City of Albuquerque

**RE: BANDELIER ELEMENTARY SCHOOL - NEW MAIN ENTRANCE (L16-D28A).
Revised GRADING PLAN FOR BUILDING PERMIT APPROVAL. ENGINEER'S
STAMP DATED April 24, 2001.**

**Re: Bandelier Elementary School New Main Entrance Grading Plan
Engineer's Stamp dated 3-28-01, (L16/D28)**

**Re: Bandelier Elementary School Grading and Drainage Plan Addendum
3309 Pershing SE
Engineer's Stamp dated 12-12-07, (L16/D28)**

BANDELLER ELEMENTARY SCHOOL
CHANGE ORDER #1, SHEET C-112-R1

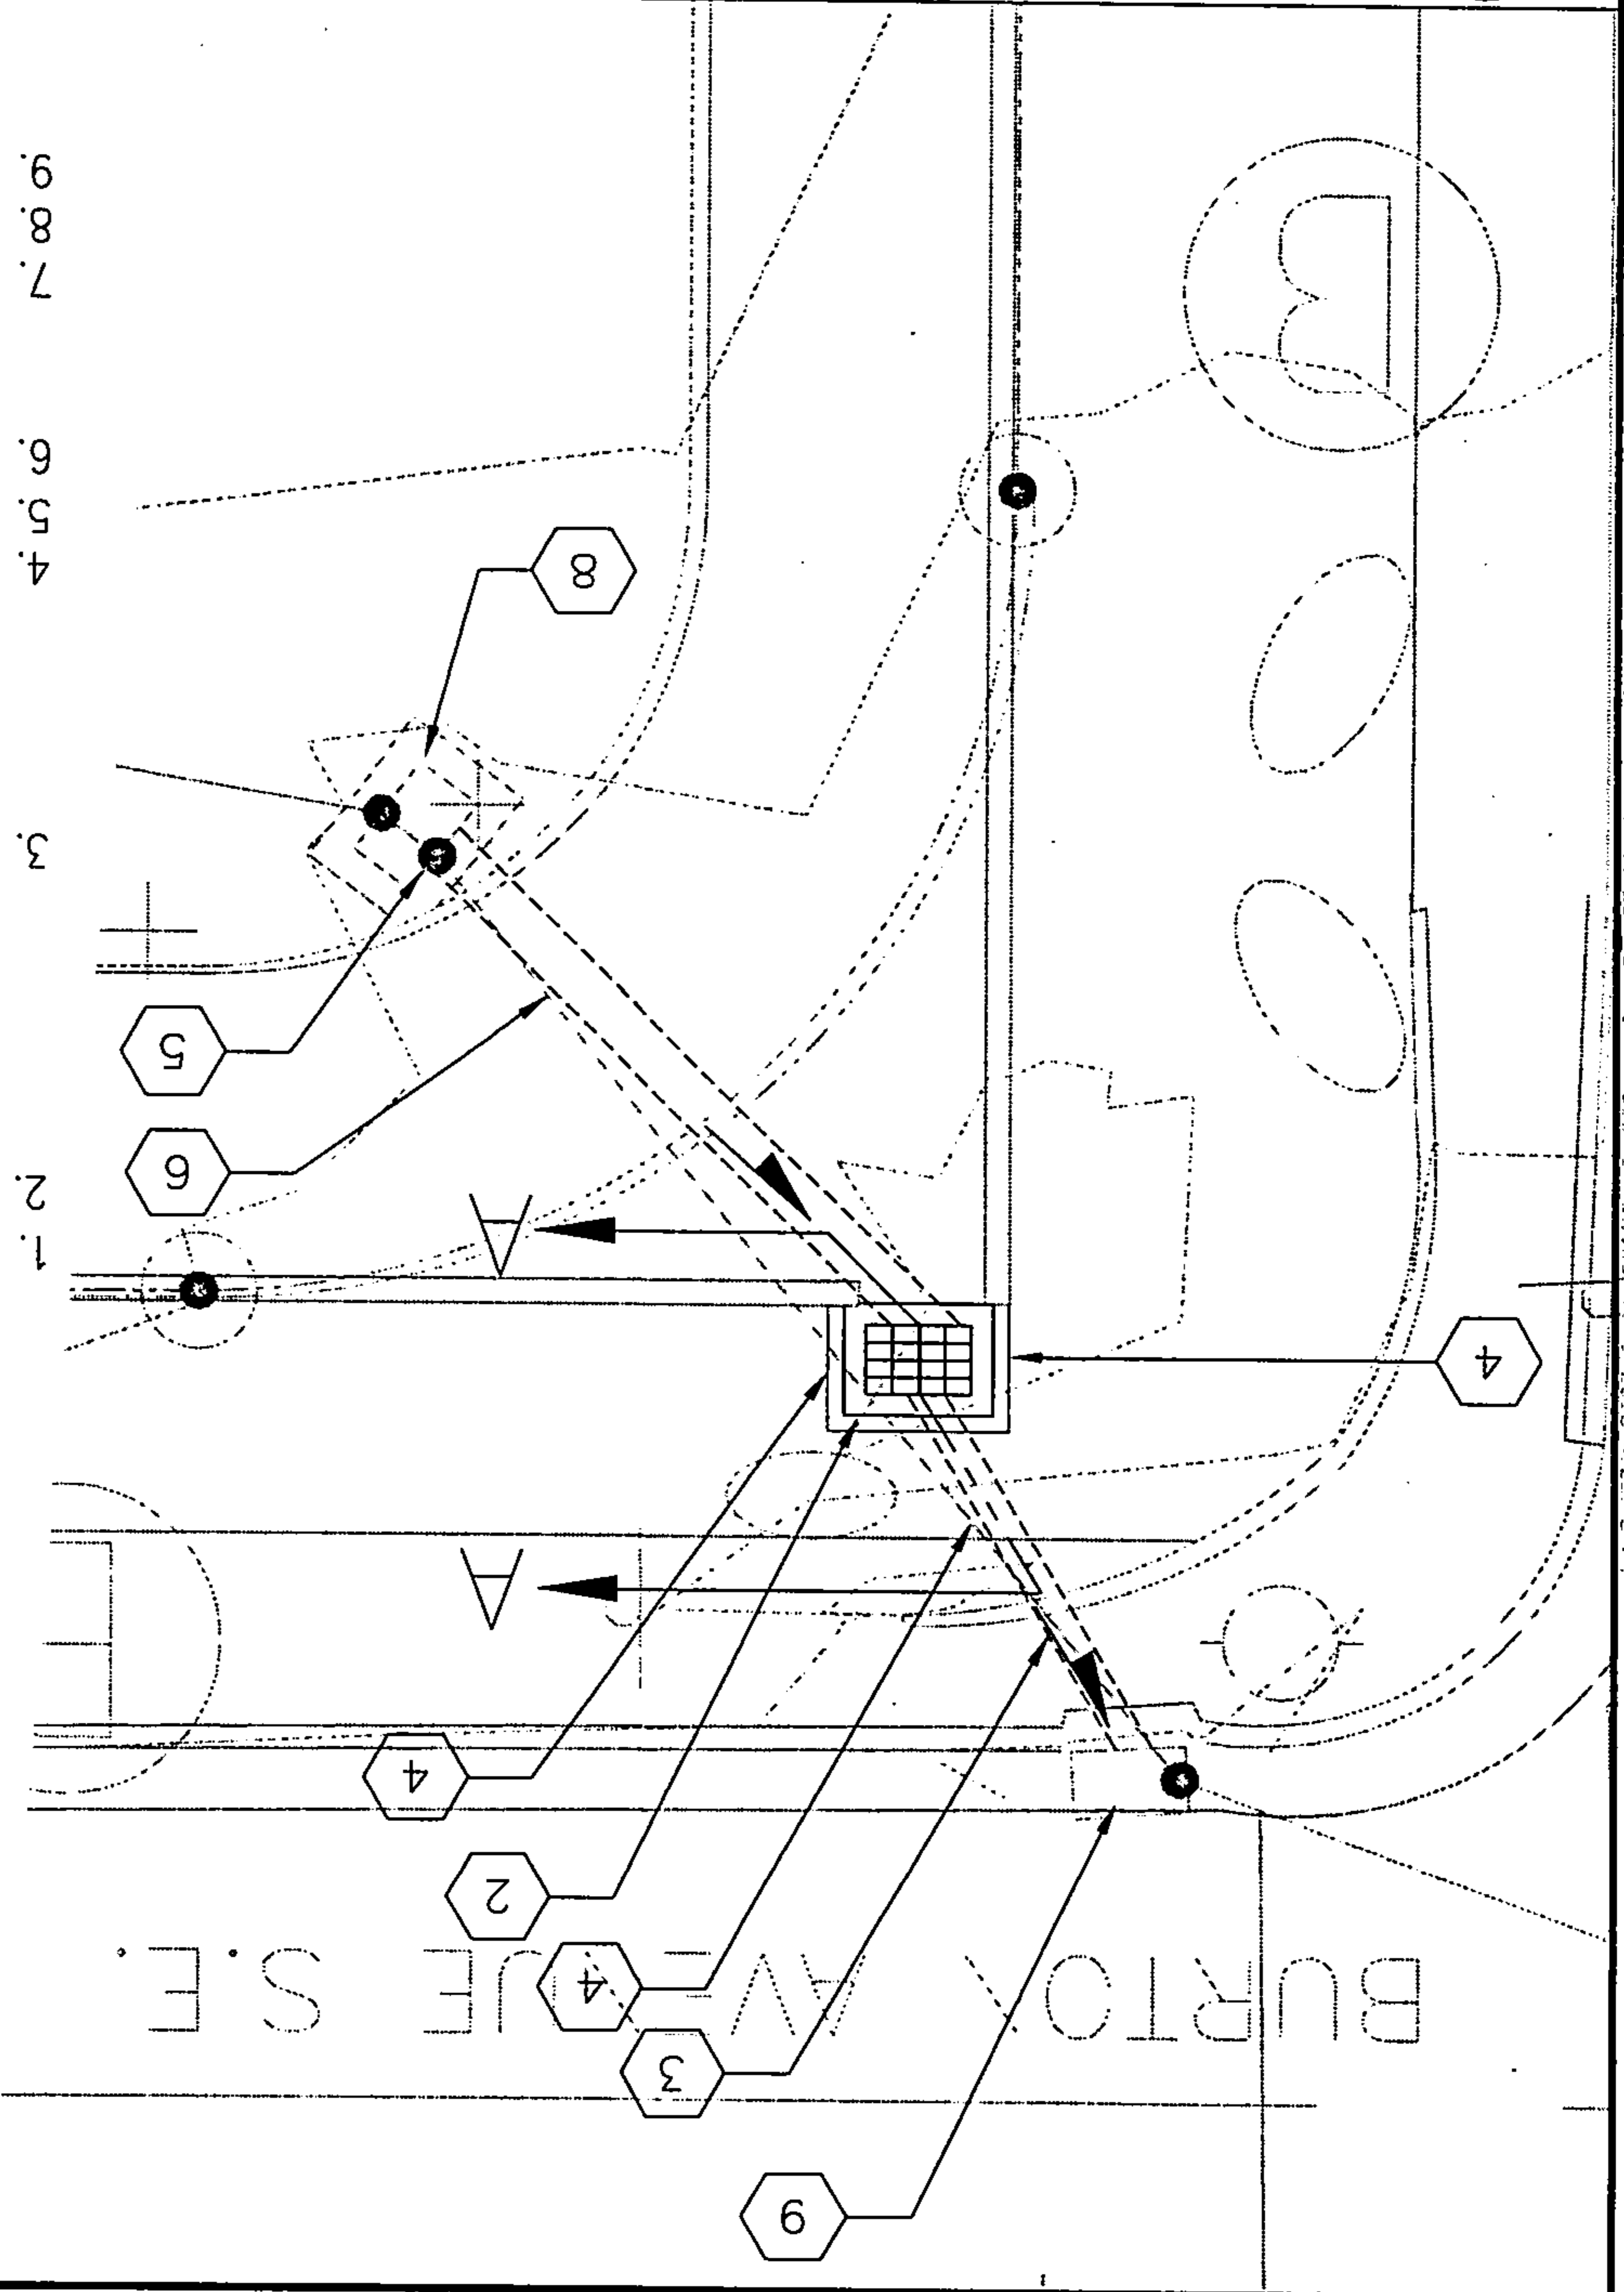
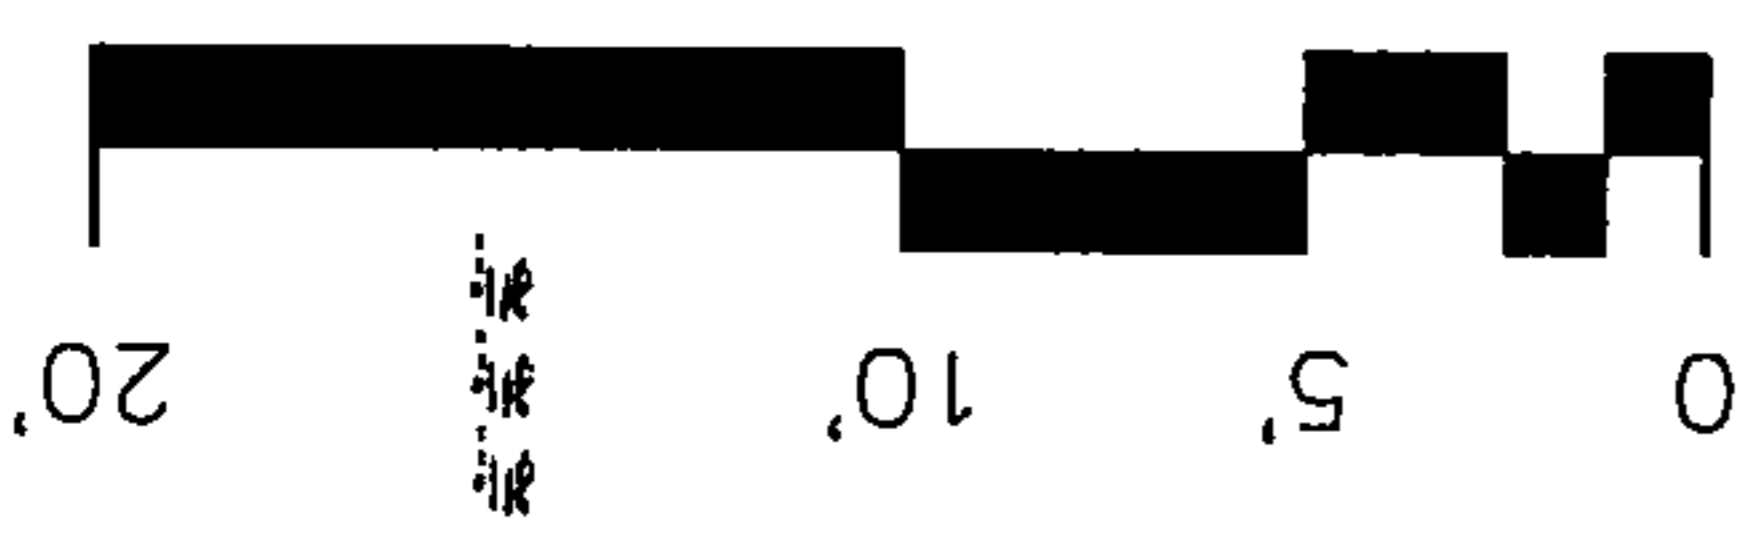
- 1. DELETED.
- 2. NEW SINGLE TYPE "D" DRAIN INLET PER COA STANDARD DRAWING #2206
TOP OF GRATE=50.34
INVERT (IN)=47.01
INVERT (OUT)=47.01
N: 5630.69
E: 5040.99
- 3. NEW 12" ϕ x 13' HDPE STORM DRAIN PIPE, S=1.5%, CONNECT TO
EXISTING CURB DI IN STREET. CONTRACTOR TO FIELD VERIFY INVERT OF
EXISTING CURB DI PRIOR TO CONSTRUCTION.
INVERT(IN)=47.01
INVERT(OUT)=46.81
- 4. SEE ORIGINAL STAMPED DRAWING.
INVERT(OUT)=46.81
- 5. SEE ORIGINAL STAMPED DRAWING.
- 6. NEW 18" ϕ x 22' HDPE STORM DRAIN PIPE, S=0.45%.
INVERT(IN)=47.11
INVERT(OUT)=47.01
- 7. DELETED.
- 8. SEE ORIGINAL STAMPED DRAWING.
- 9. EXISTING CURB DI. REMOVE ALL SILT AND DEBRIS AND FILL INVERT OF DI TO
EXISTING DRAIN PIPE ELEVATION (INVERT=46.71) WITH CONCRETE, SLOPE
INVERT TO DRAIN TO EXISTING DRAIN PIPE. *Seal w/ Non-Swink GROUT #10*
